Access Compliance Report

Public Rights-of-Way

Intersection ID: 11265	Main Street: N_TRYON_ST	Cross Street: WADSWORTH_PL	Location: W
ADA ID: 80A7DCE5004A	Ramp Type: Perp	Initial Pass/Fail: Fail	Overall Compliance: No
Severity Score: 8.75			
Codes/Mitigation Info/Possible Solution		Field Measurements/Component Compliance

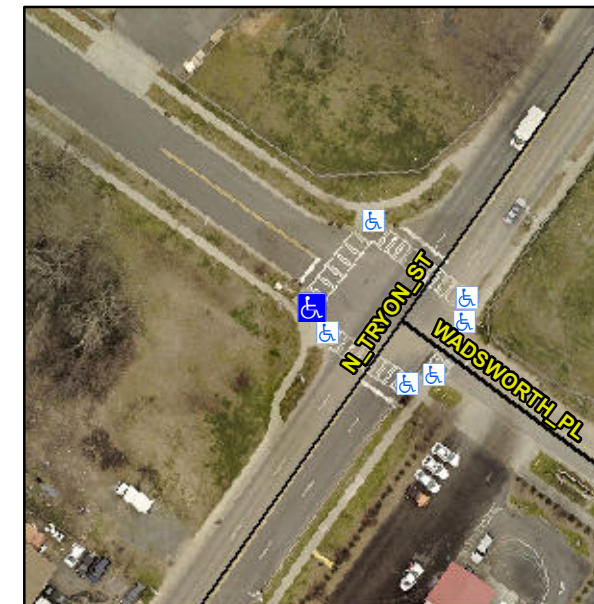
Not Found, R304.5.1

Compliance	Description	Data	Compliance	Description	Data
N/A	Ramp Length (in)	94.0	Yes	Ramp Slope (%)	7.4
No	Ramp Width (in)	47.0	Yes	Ramp XSlope (%)	1.3
N/A	Flare Type LT	N/A	N/A	Flare Type RT	N/A
N/A	Flare Slope LT (%)	N/A	N/A	Flare Slope RT (%)	N/A
N/A	Flare Traversable LT?	N/A	N/A	Flare Traversable RT?	N/A
N/A	Landing Length (in)	N/A	N/A	DWS Provided?	N/A
N/A	Landing Width (in)	N/A	N/A	DWS Contrast?	N/A
N/A	Landing Slope (%)	N/A	N/A	DWS Length (in)	N/A
N/A	Landing X Slope (%)	N/A	N/A	DWS Full Width?	N/A
N/A	Landing Curb? (Y/N)	N/A	N/A	DWS Offset (in)	N/A
N/A	Shared Landing?	N/A			
N/A	Gutter Ponding?	Yes	N/A	Gutter Slope (%)	N/A
N/A	Gutter Lip Ht (in)	N/A	N/A	Gutter X Slope (%)	N/A
N/A	Painted X Walk1?	Yes	N/A	Painted X Walk2?	N/A
	X Walk 1 Direction	To NE		X Walk 2 Direction	N/A
N/A	X Walk 1 Width (in)	118.5	N/A	X Walk 2 Width (in)	N/A
	X Walk 1 Slope (%)	3.8		X Walk 2 Slope (%)	N/A
	X Walk 1 X Slope (%)	2.3		X Walk 2 X Slope (%)	N/A

Remove & Replace Entire Ramp.
